### ADDENDUM 1

CSP 22-92

## Cavazos Elementary School Heating & Air Condition (HVAC) Improvements Funded through the Elementary & Secondary Emergency Relief (ESSER) Funds May 31, 2022

## Addendum

DATE: 05/05/2022  
DRAWN BY: DBR  
CHECKED BY: DBR  
PROJECT NUMBER: 218007.005  
SHEET TITLE: LEVEL 1 MECHANICAL PLAN - AREA C  
SHEET NUMBER: M2.13C

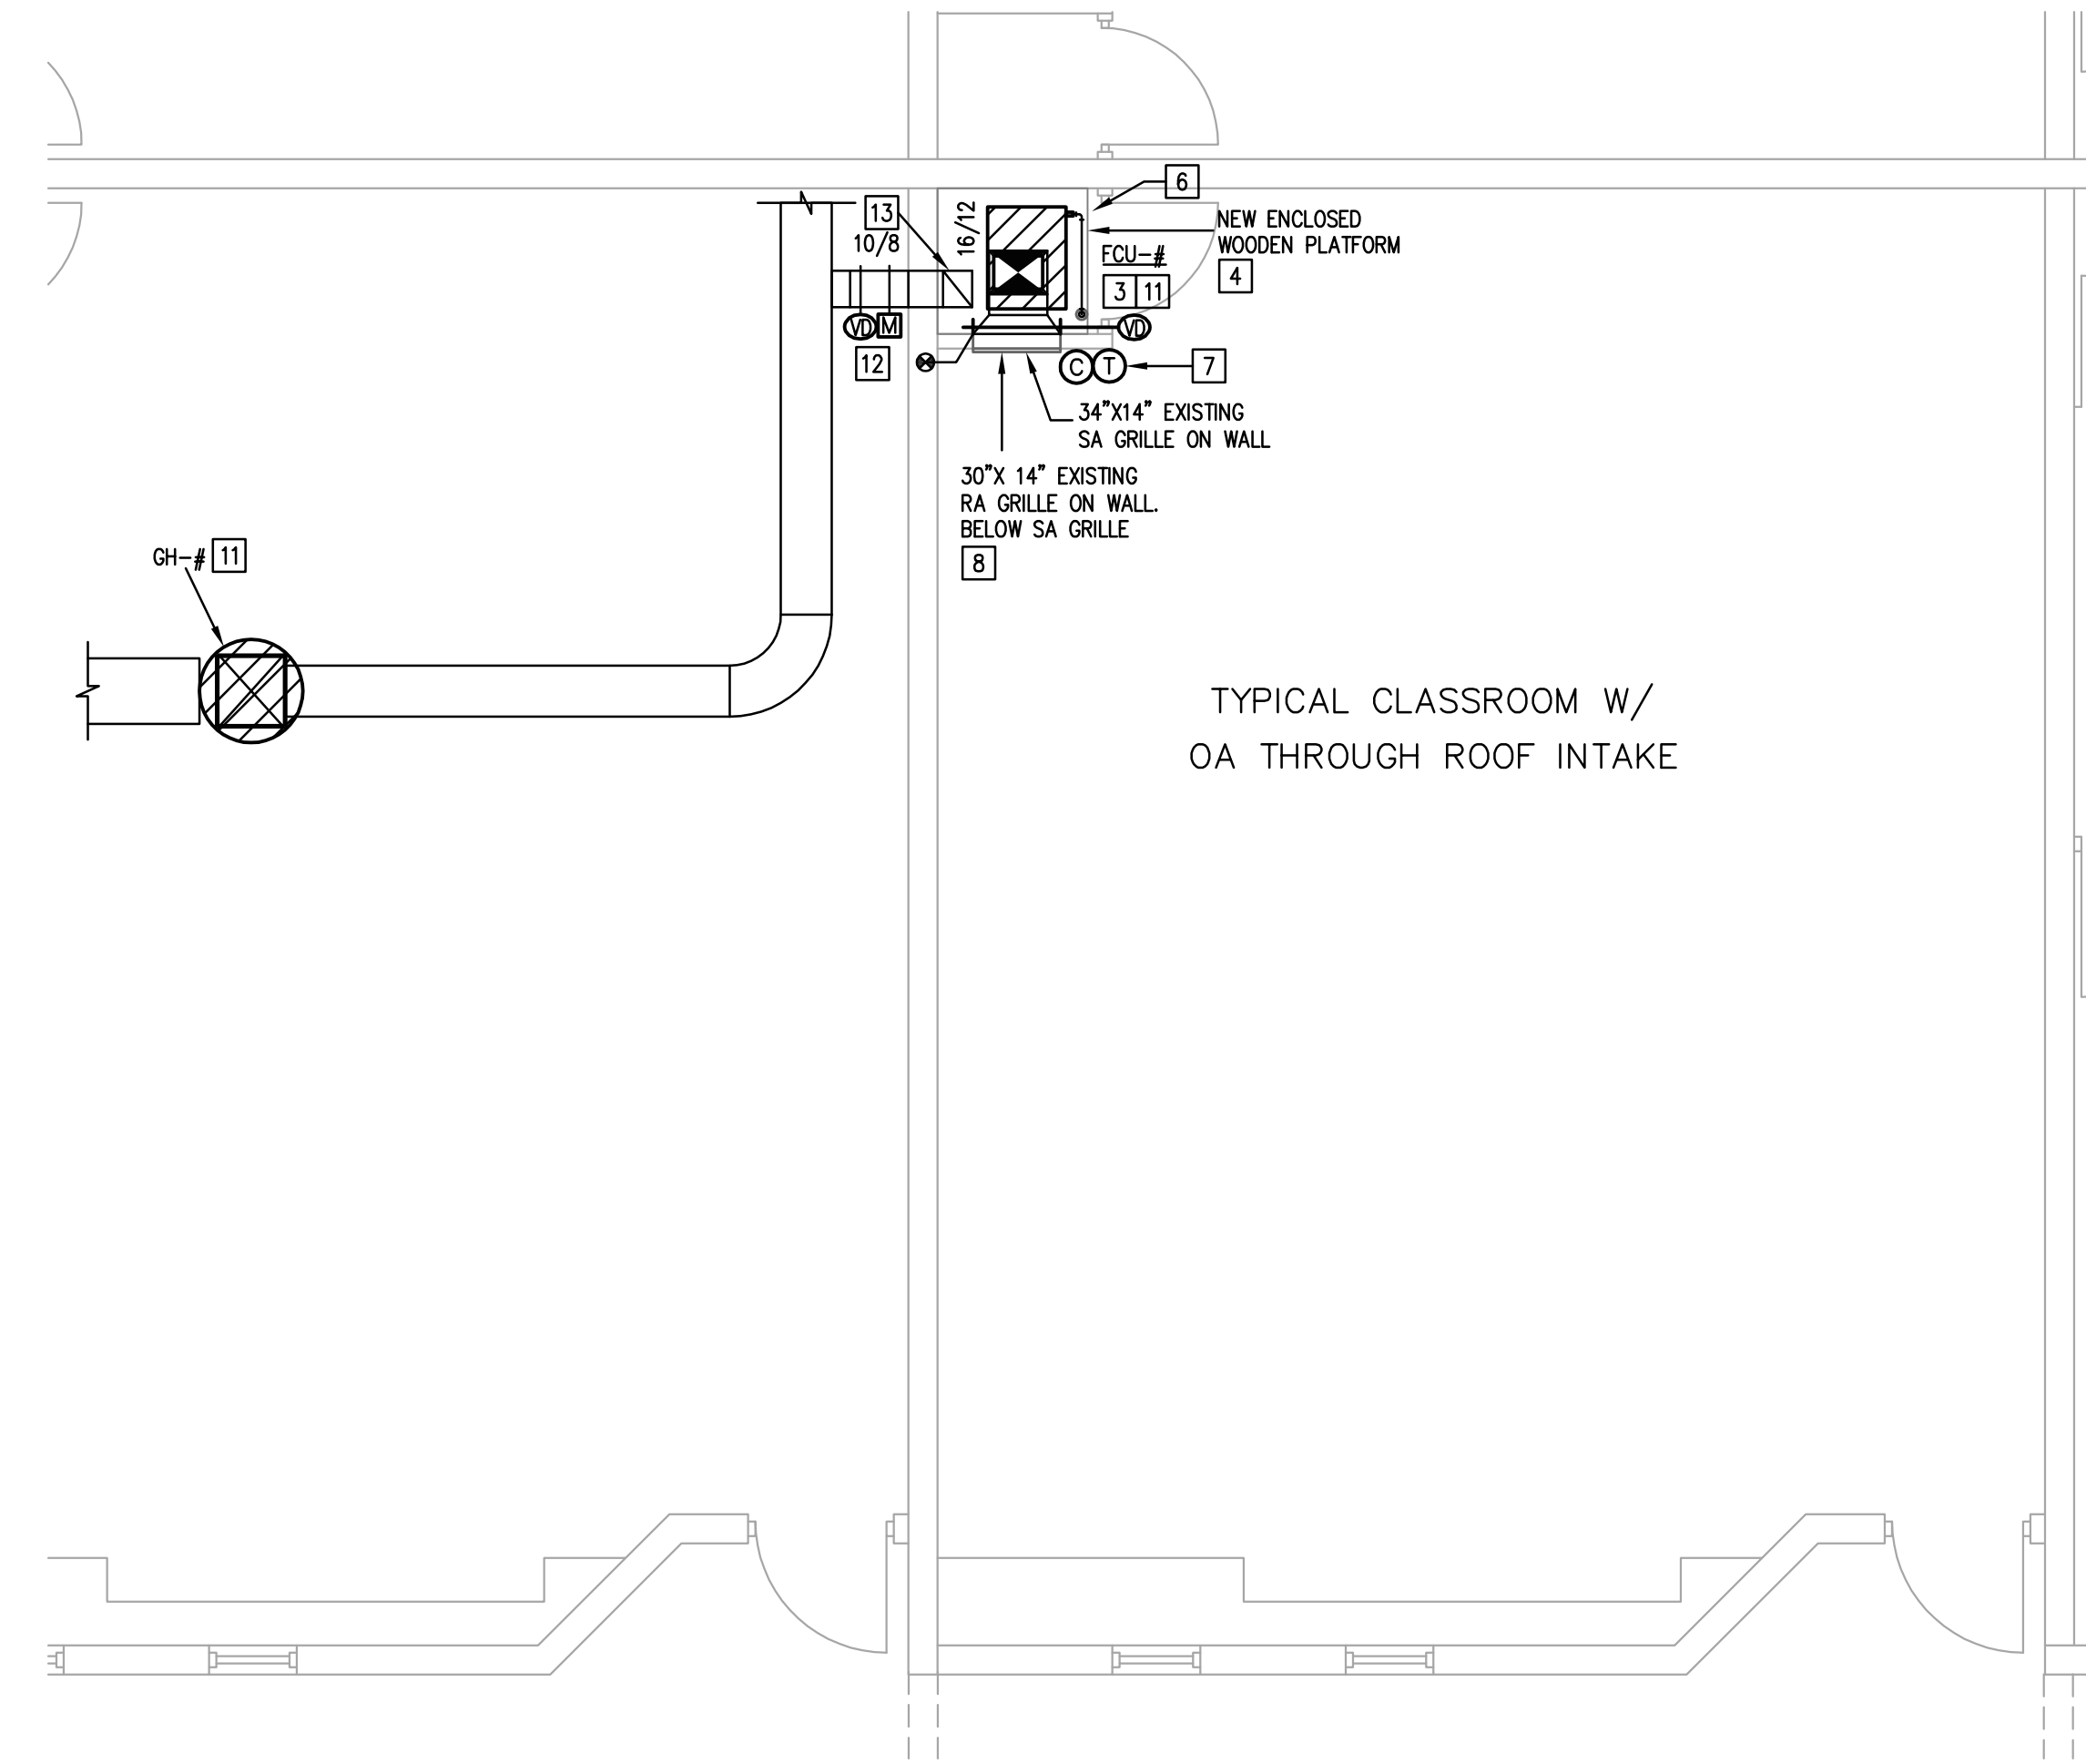
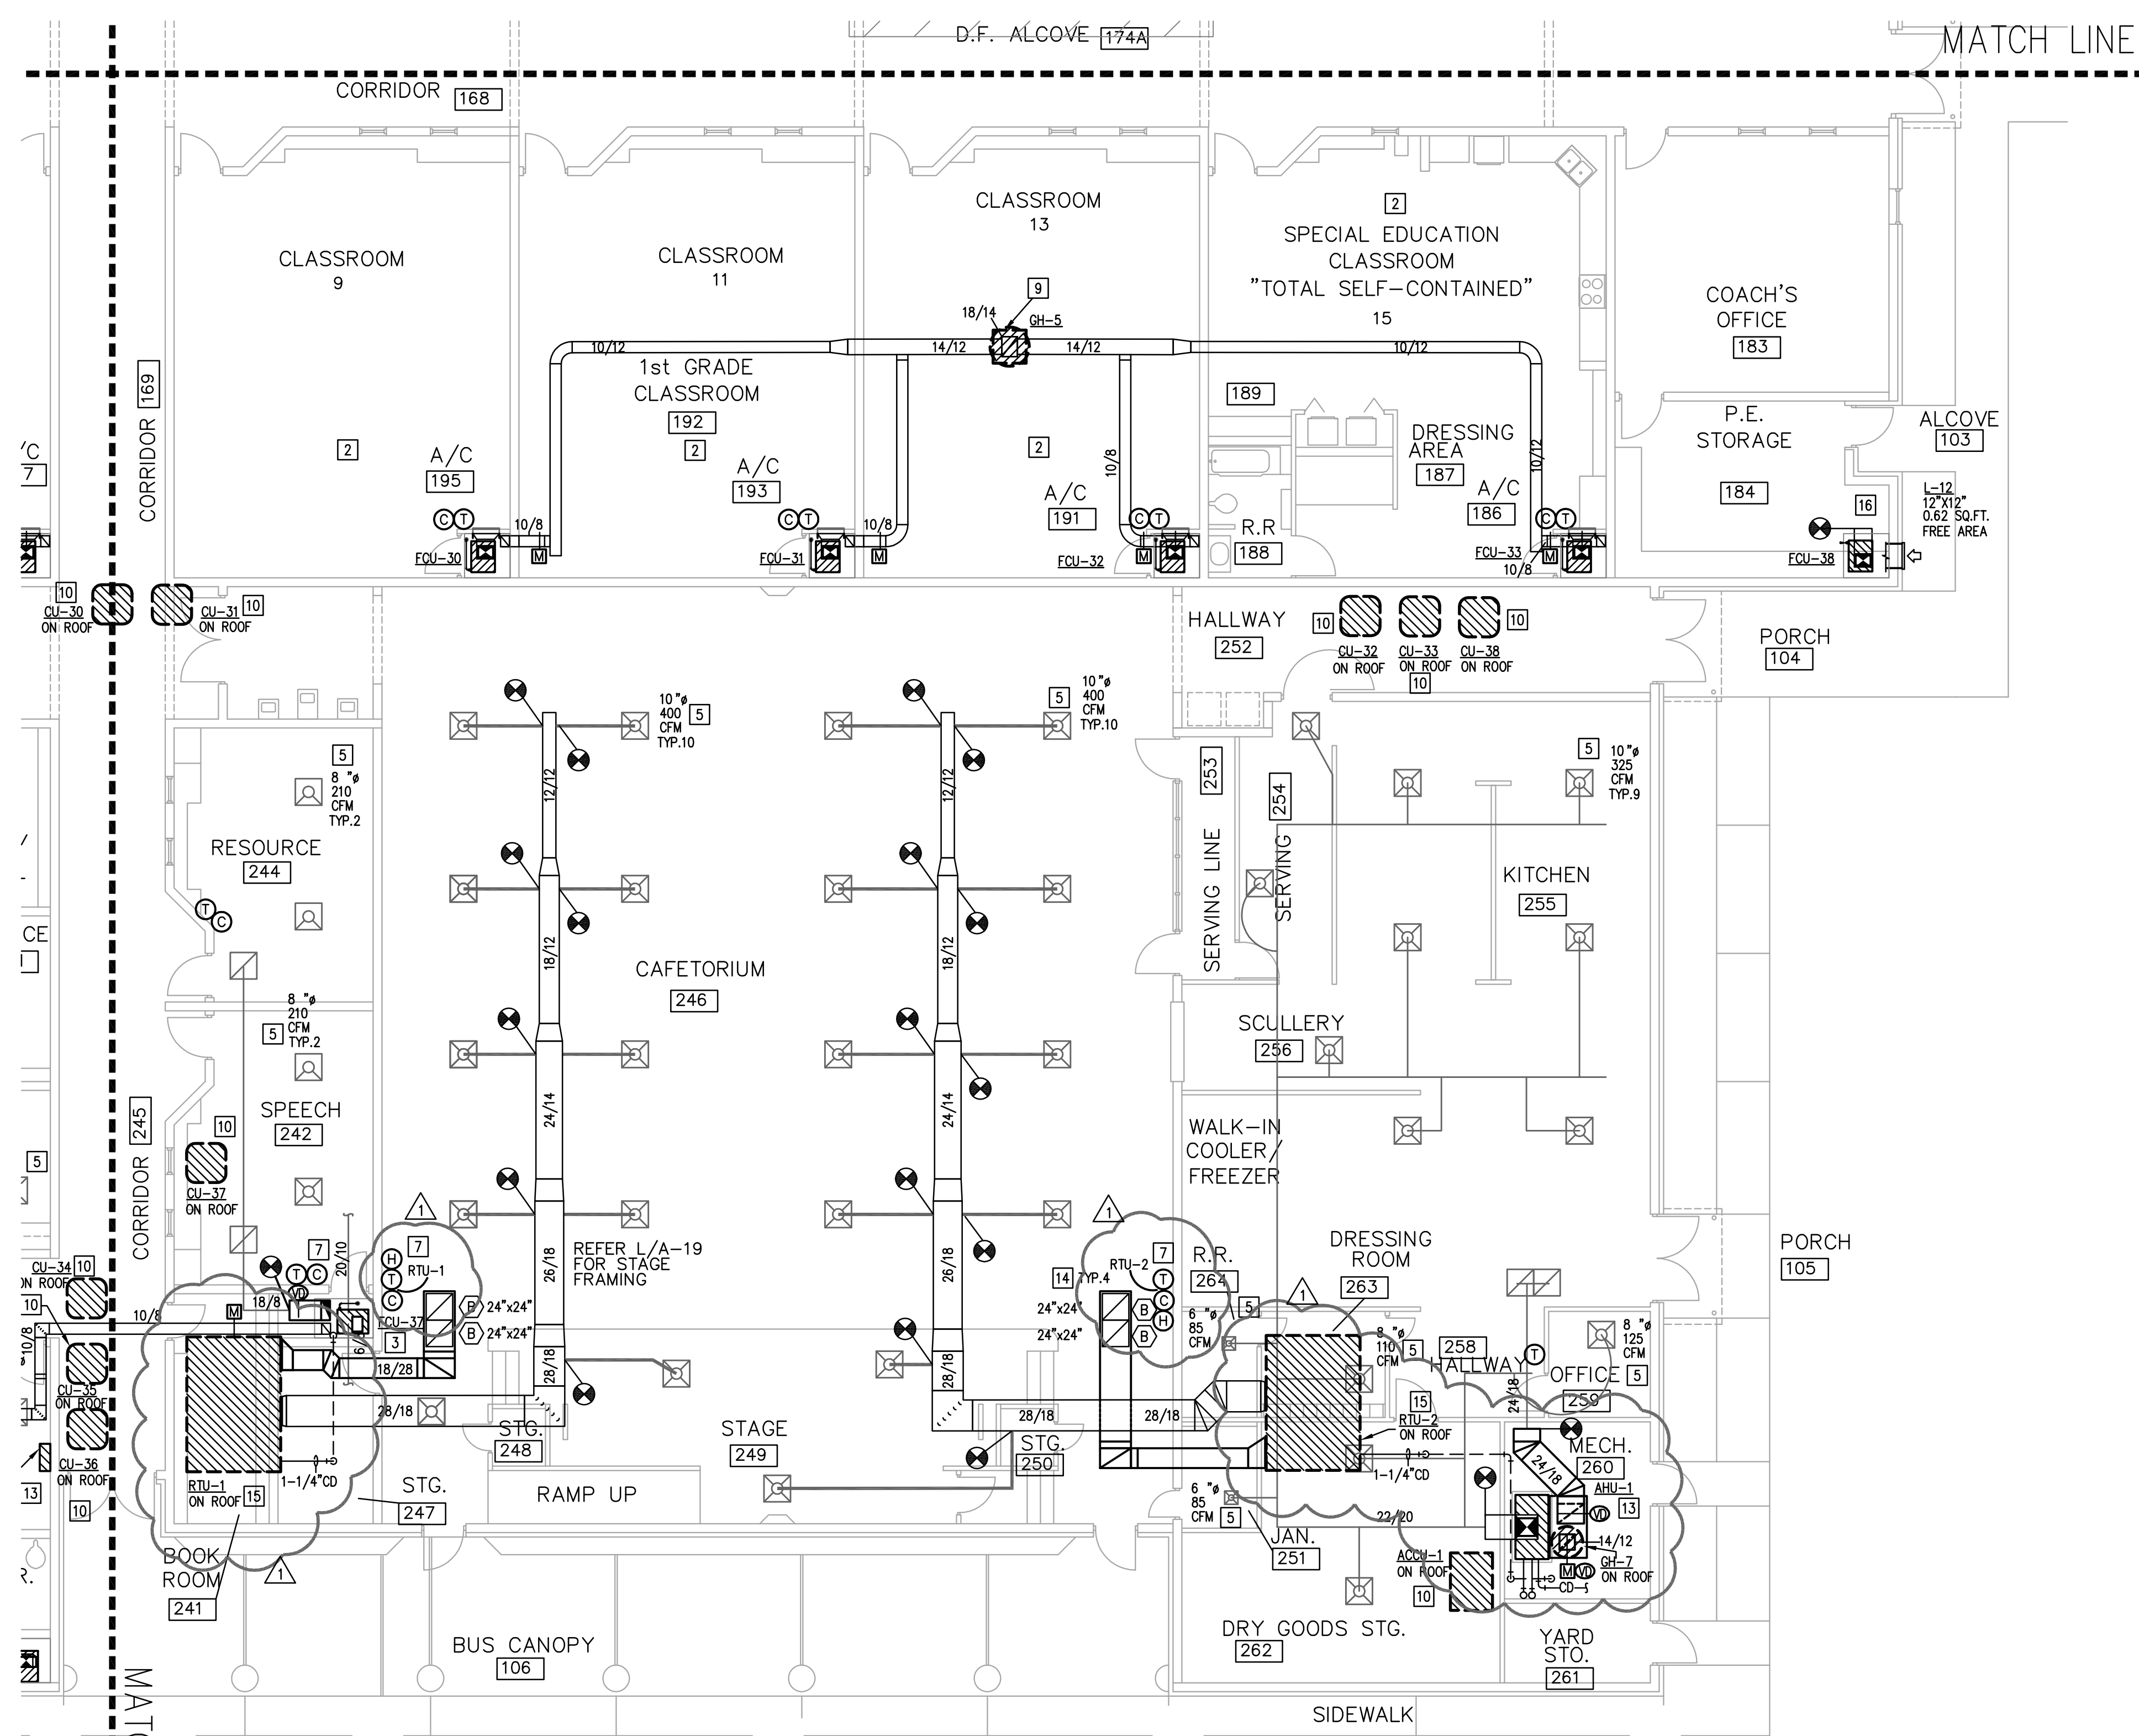
#### M2.13C – Level 1 Mechanical Plan – Area C

- A. Revised keyed notes 1, 7.
- B. Indicate condensate piping for RTU-3, 4.
- C. Added H'stat for RTU-3 and RTU-4.
- D. Added ceiling mounted exhaust fan EF-1 in Clinic 237. Route exhaust duct as indicated on M2.13C. Route up to gravity hood GH-8 on roof. Coordinate final gravity hood location and roof opening with structural members. Refer to detail 19/M4.01 AND 25/M4.01.
